INTERNAL MEMORANDUM

Memo number: 4
Date of previous memo: 01/04/2026
Date: 19/05/2026

SUBJECT: P/25/0294 - The Norton, Penydarren New vehicular access, creation of 6 units in the Norton, construction of two dwellings and landscaping and parking area within site.

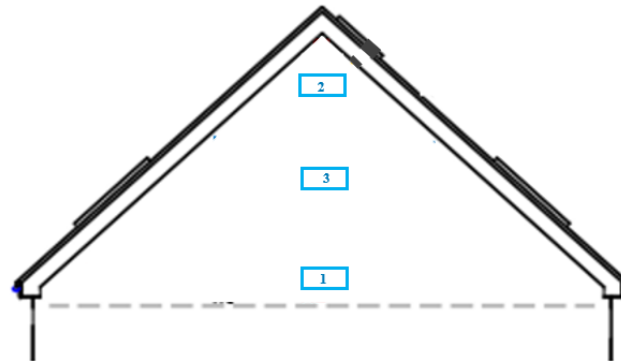
- Previous comments suggested the use of seeded grasscrete for the hardstanding areas. This does not seem to have been added to the plan.

The re-submitted Document 2 appears to be very similar to the document submitted previously. NB the version number/code and date have not been amended – please can this be amended.

There is still no reference to the use of grasscrete.

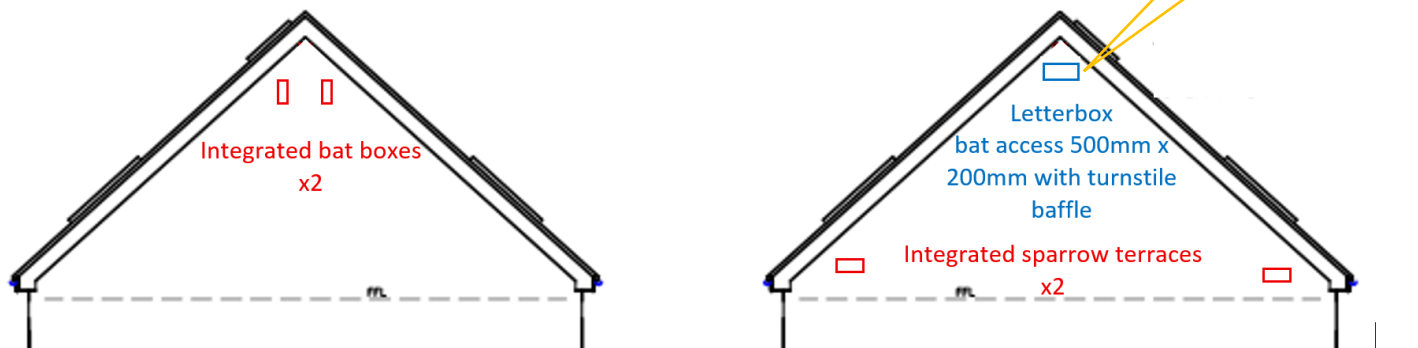
- Document 1 states there will be x2 integrated bat boxes and x2 integrated sparrow terraces built into the new properties, however, Document 2 only shows one of each.

Also, the sparrow terrace is shown too close to the letterbox style bat opening on the northeastern gable.

Please amend the drawings as below.

Curiously, the most recently submitted Document 2 seems to have reverted to one bat box and one bird box. As stated above there should be two of each. This needs amendment.
